2002 Ford Mustang GT V8-4.6L SOHC VIN X

IGNITION SWITCH - HIGH TURNING EFFORT/MIL ON/DTC'S SET

01-21-13

^ DRIVEABILITY - DIAGNOSTIC TROUBLE CODES
(DTC) P0500, P1502 AND/OR U1039 CONTINENTAL
MODELS ONLY - STICKING OR BINDING IGNITION
LOCK CYLINDER - HIGH EFFORT WHEN TURNING
IGNITION SWITCH

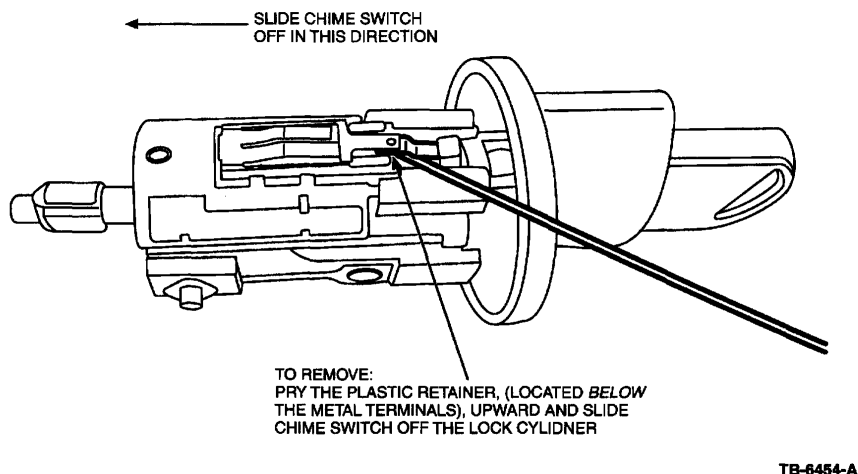
4. Remove the Plastic Key chime warning switch by prying upward on the plastic retainer, while sliding the switch away from the key insertion end (Figure 1). Refer to the appropriate model Workshop Manual, Key-in-ignition warning switch removal and installation section located in Section 413 if additional detail is required.
5. Install a new Key-In-Ignition warning chime switch XL2Z-11A127-AB and reinstall lock cylinder.
6. Verify proper function of the Ignition Switch Lock Cylinder and Key-In-Ignition warning chime switch.

Replace the KEY-IN-IGNITION WARNING CHIME SWITCH located on the ignition switch lock cylinder with revised part XL2Z-11A127-AB. Refer to the following Service Procedure for details.
